PROJECT: Centennial Heights Townhomes

CITY OF LAS VEGAS		DATE:
INTER-OFFICE MEMORANDUM		June 29, 2020
TO: Land Development Services Department of Building & Safety		FROM: Albert Sung, P.E. Flood Control Project Engineer Department of Public Works
SUBJECT:	Drainage Study for:	COPIES TO:
Centennial Heights Townhomes		Horrocks Engineers
Cross Streets:	SWQ of Centennial Pkwy & Shaumber Road	Harmony Homes, LLC
File Number:	F:\Depot\DSMemos\DS5232D.doc	Bart Anderson, P.E., DevCo
Parcel Number:	126-25-201-010	CCRFCD
Zoning Action:	TMP-77575; VAC-77574; VAR-77573 & ZON-77572	
FEMA Flood Zone	YES	NO X
Proposed Storm Drain	YES X	NO

ADDENDUM #3

**RE: Addendum #3 to Technical Drainage Study for Centennial Heights Townhomes
DS 5232**

Grading Plans

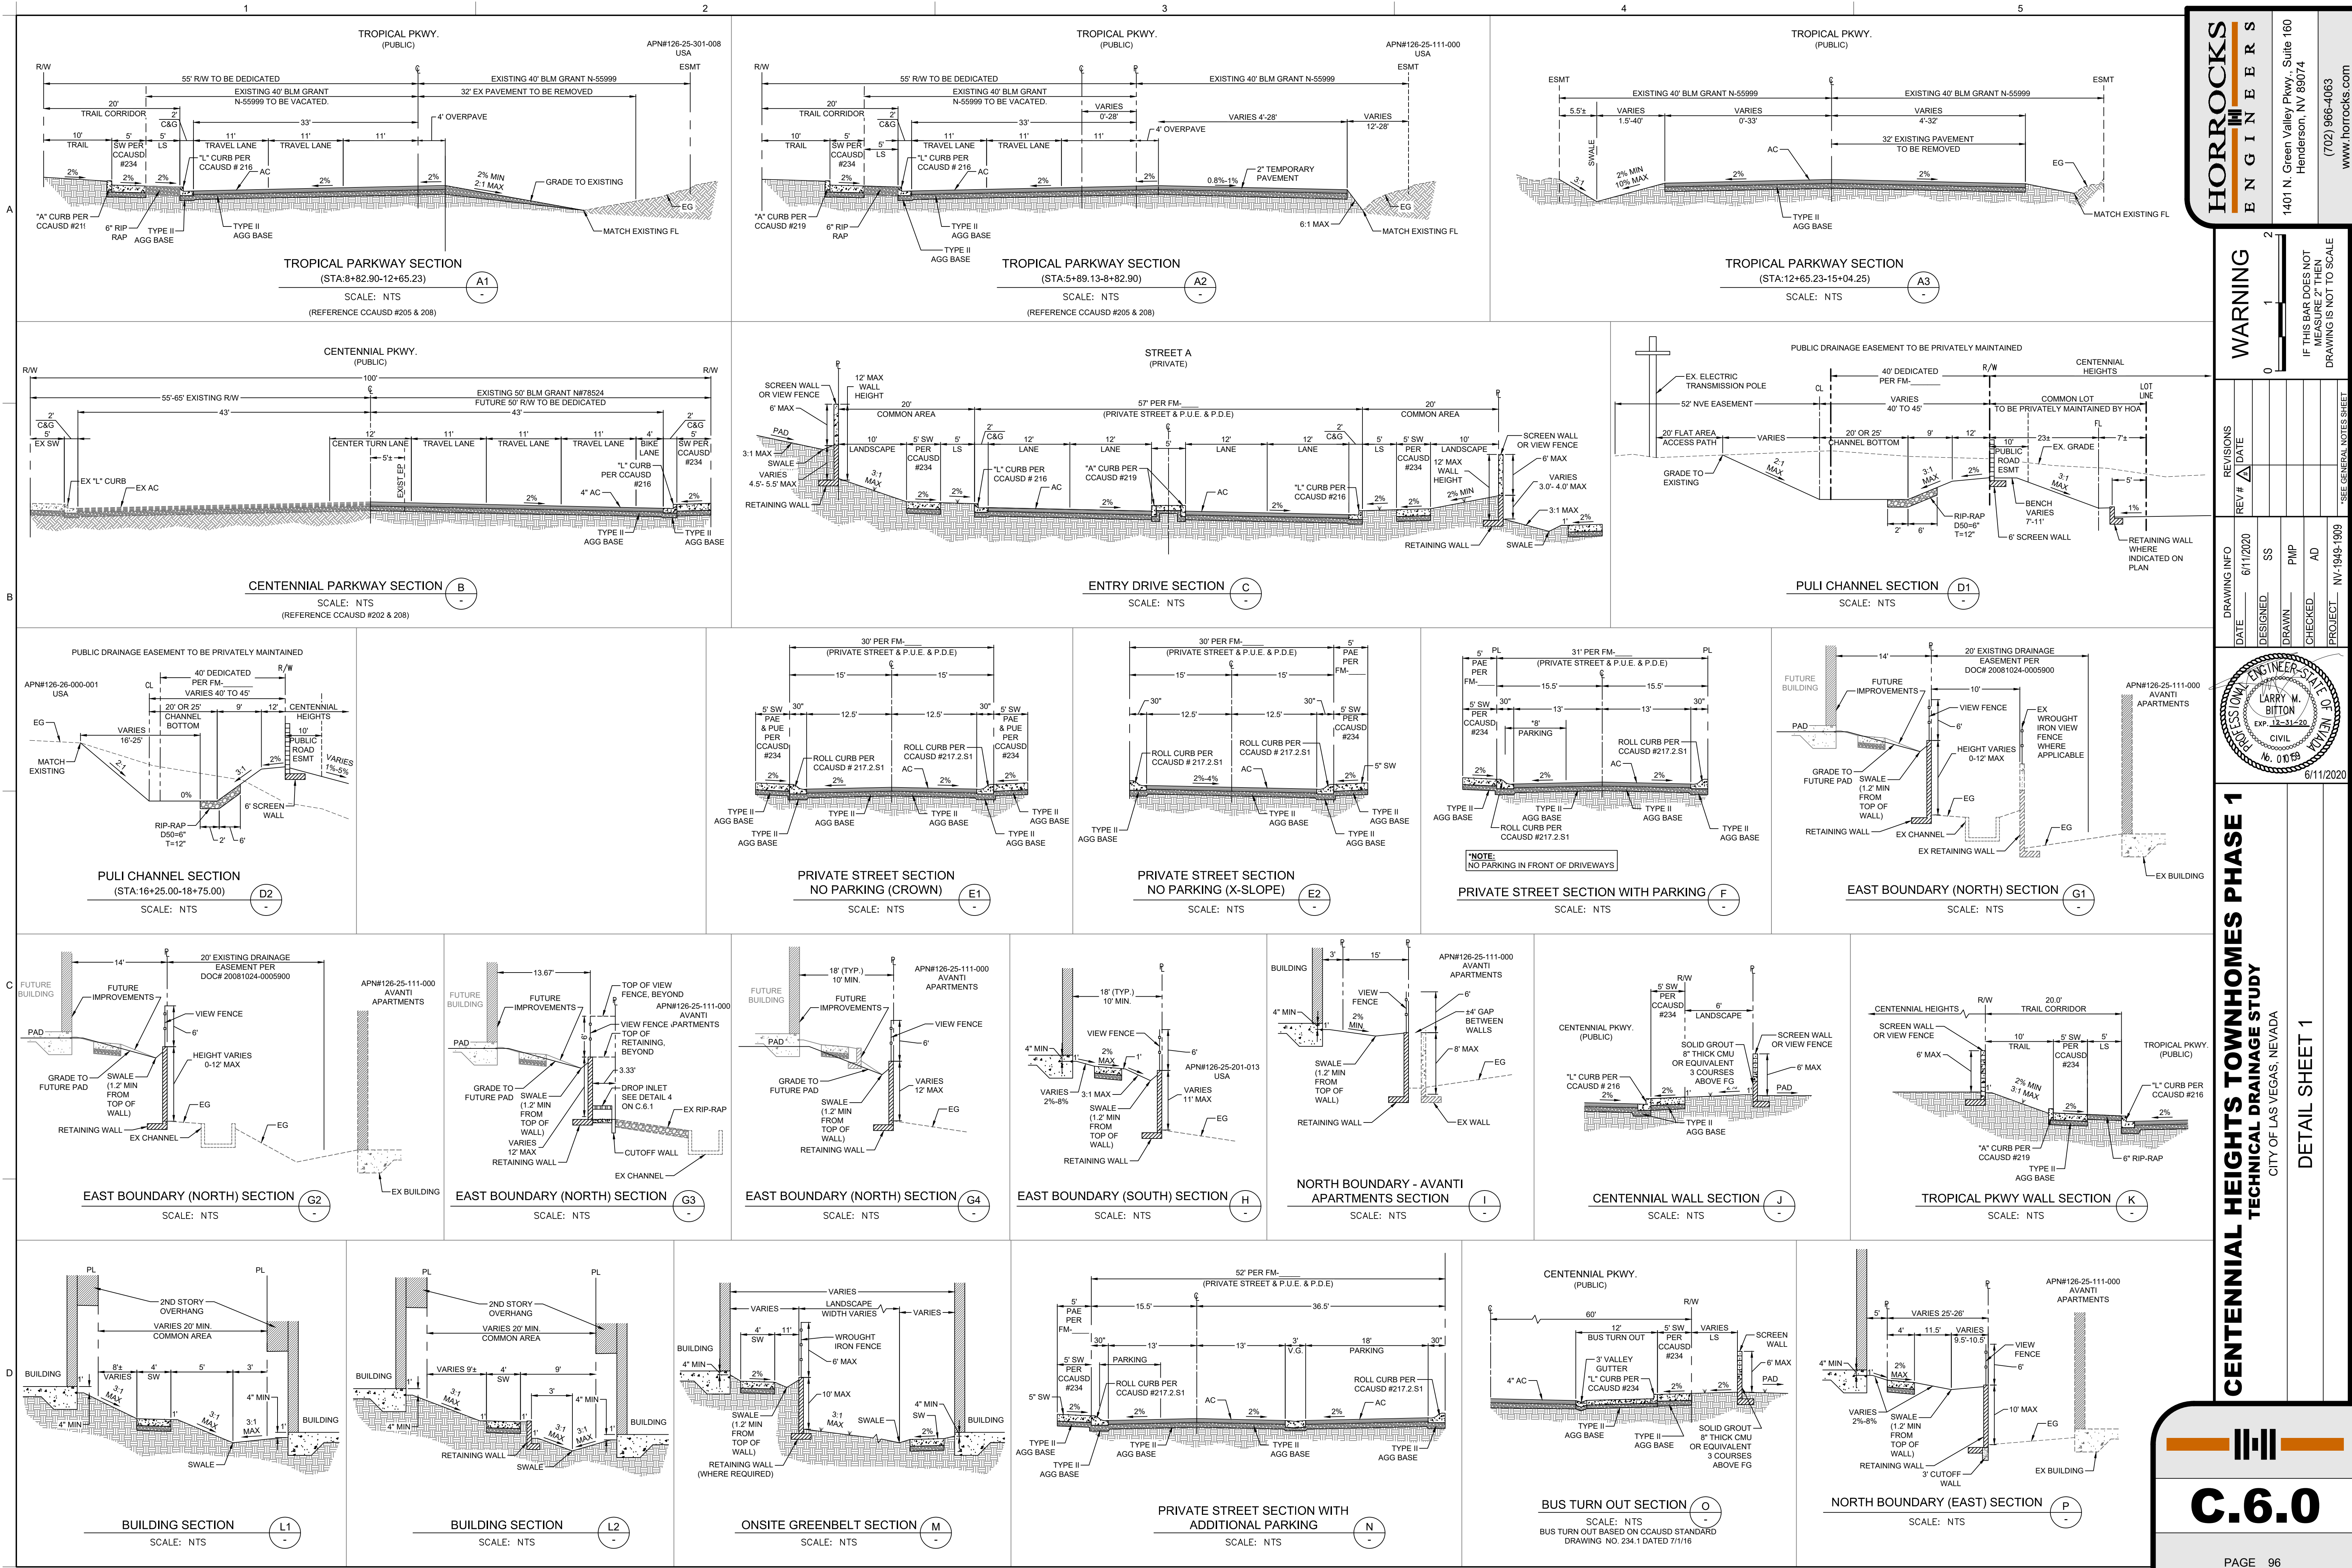
6. **In *Phase 2 Improvement Plans, Detail Section G3/C.6.0*, show a proposed storm drain / bubbler in the detail.**

RESPONSE: The bubbler is proposed with the Phase 1 improvements. The phase 2 detail Section G3/C.6.0 now labels the proposed storm drain/bubbler as "ex drop inlet/bubbler per Phase 1 plans." the detail Section G3/C.6.0 now labels the proposed storm drain/bubbler in the detail appropriately.
